WATER PERMIT NO. 2423-2

**SOUTH DAKOTA
VESTED WATER RIGHT NO. 2423-2**

GENE DEVCHAR
DAM RESTORATION
HARCON CO. SD.

REPORT ON
VESTED WATER PERMIT APPLICATION NO. 2423-2
Gene Deuchar
June 10, 1999

EARTH DAM

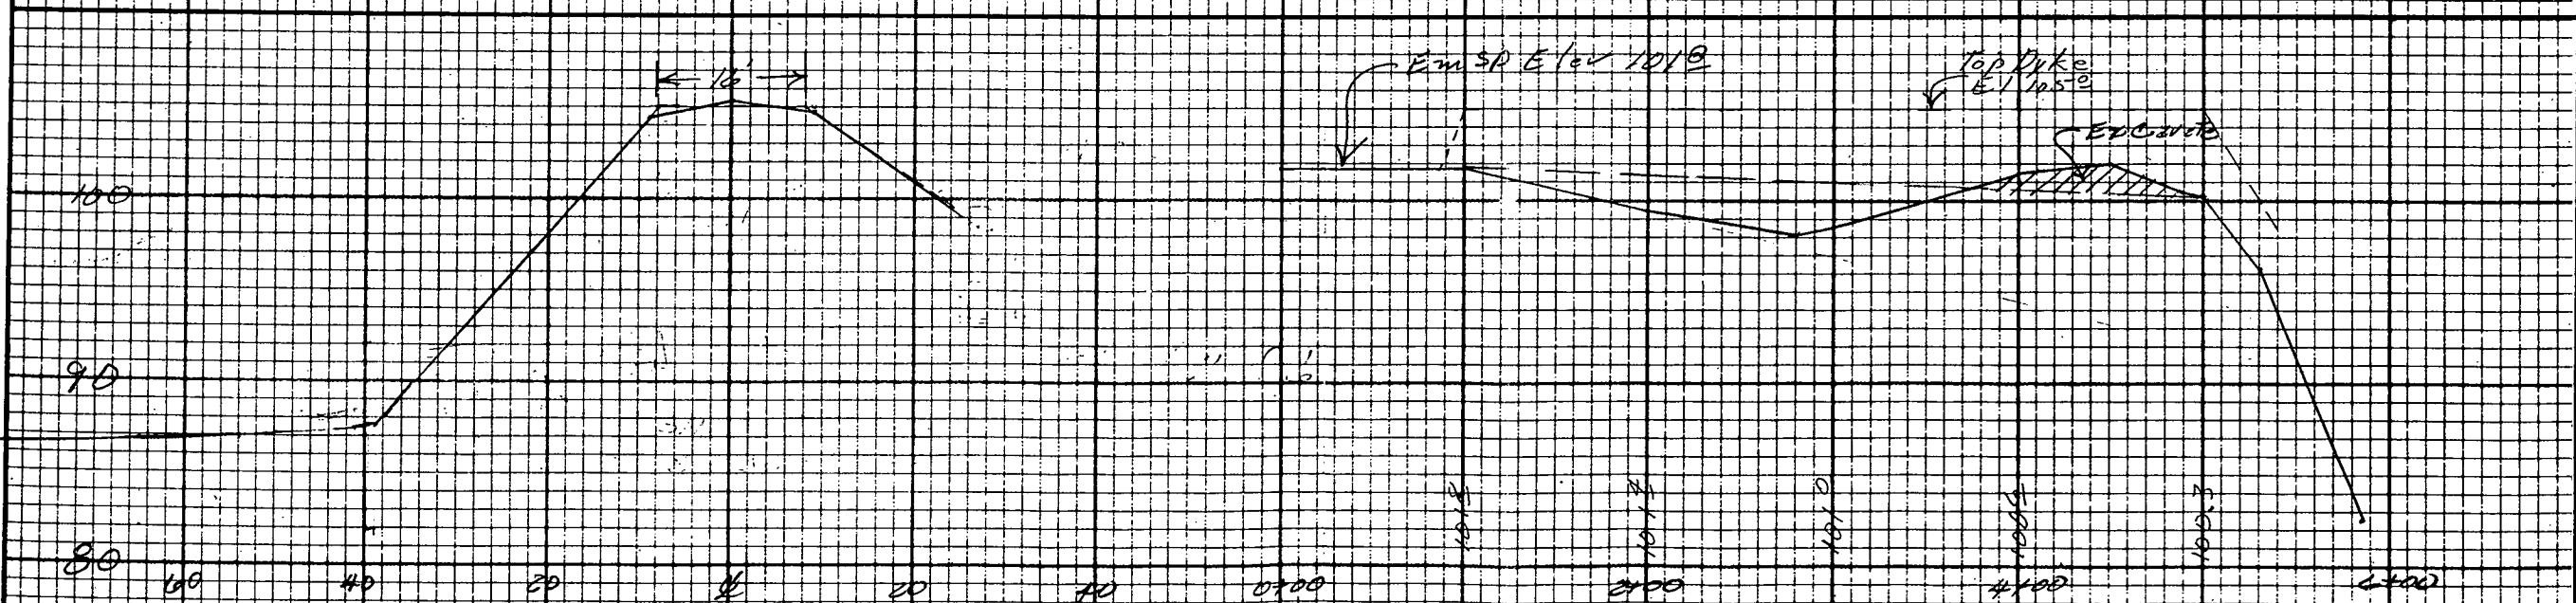
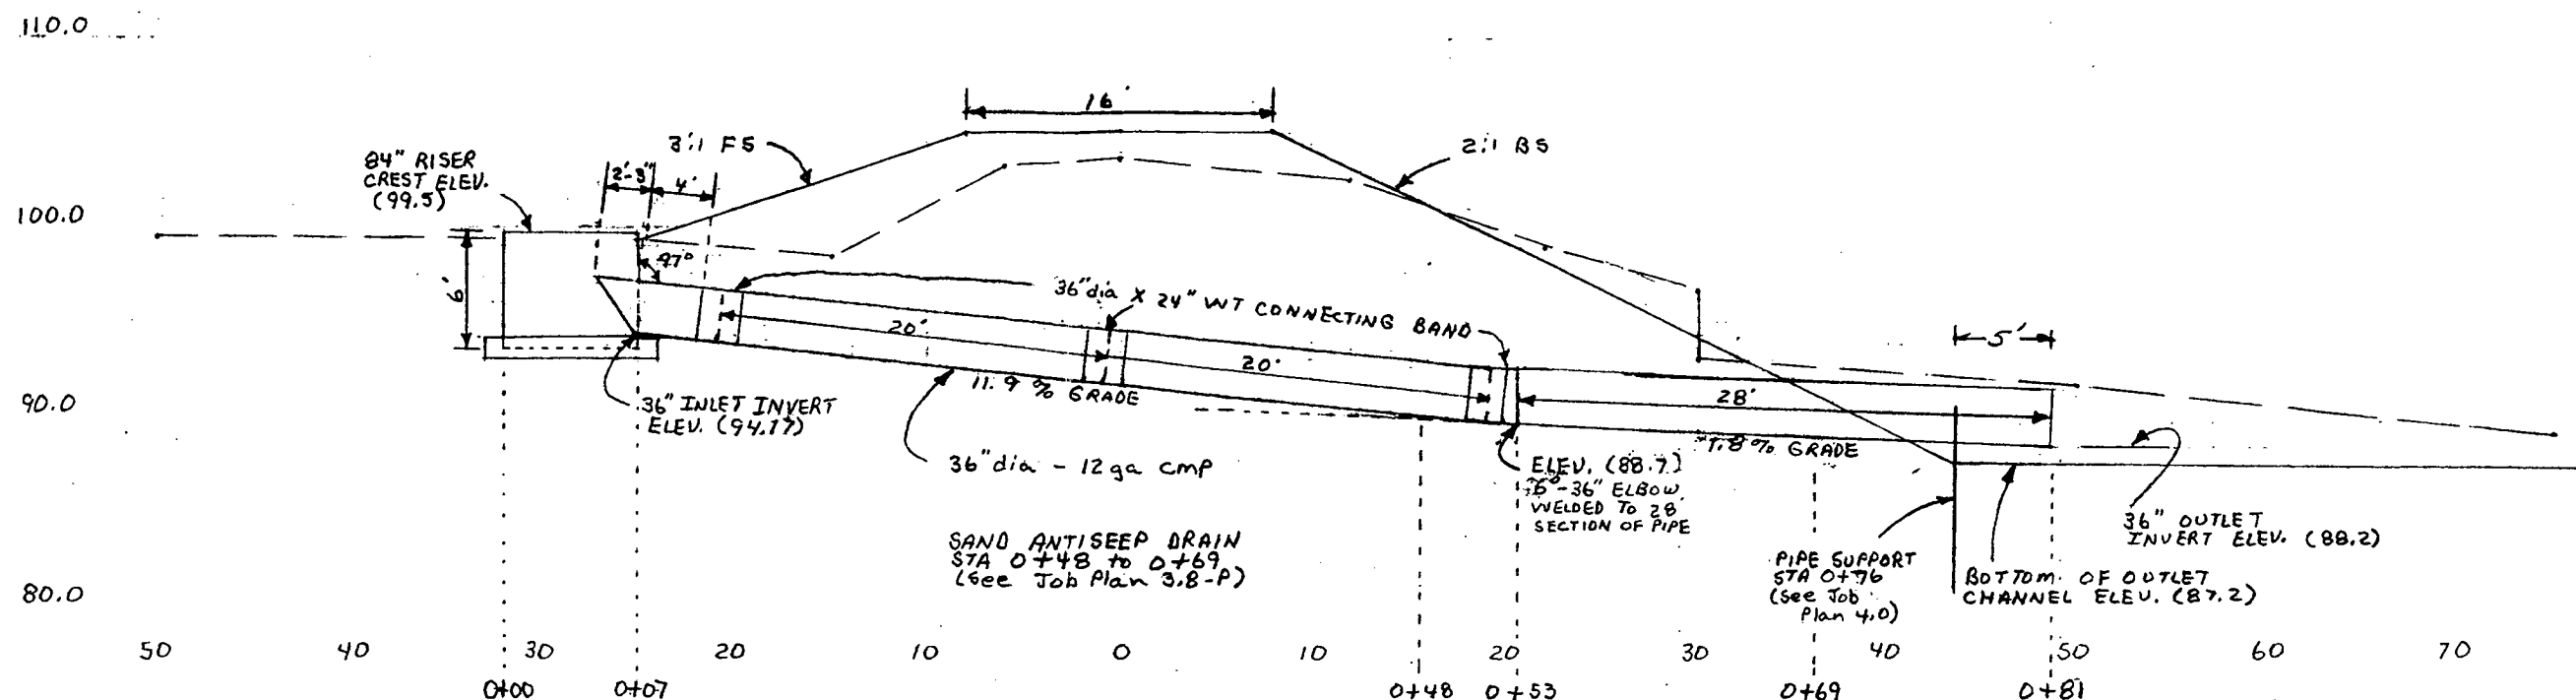
P's Review

Existing Cat. 3 - Low Hazard Dam

Top of Dam Elev. - 105
2nd Spillway Elev. - 101.8
P. Spillway Elev. - 99.5
DIS Toe Elev. - 86

Normal Storage Capacity = 109 A.-Ft
Int. Storage Capacity = 151.2 A.-Ft
Max. Storage Capacity = 210 A.-Ft

Int Capacity x Eff HT. = $151.2 \times 15.8 = 2389 < 3000$ ∴ 25 year
Minimum Spillway Design

1. Topo Map - OK
2. Dam Axis Profile - OK
3. Dam Max X-Sec. - OK
4. Area Capacity - OK
5. Outlet Details - OK
6. Spillway Rating - OK
7. Spillway Details - OK
8. Specs. Std NRCS - OK
9. EPP - N/A Cat. 3 - OK

We have reviewed the plans and specifications for the repair of your dam located in the NW ¼ of Section 18-T5N-R20E, in Haakon County. The plans and specifications as submitted are approved. Approval of the plans and specifications does not authorize construction of the dam. Construction may not begin until Vested Water Right Application No. 2423-2 is approved.

The Deuchar Dam will be classified as a small size Category 3, Low Hazard dam with a dam height of 19 feet and a normal storage capacity of 109 acre-feet and a maximum storage capacity of 210 acre-feet.
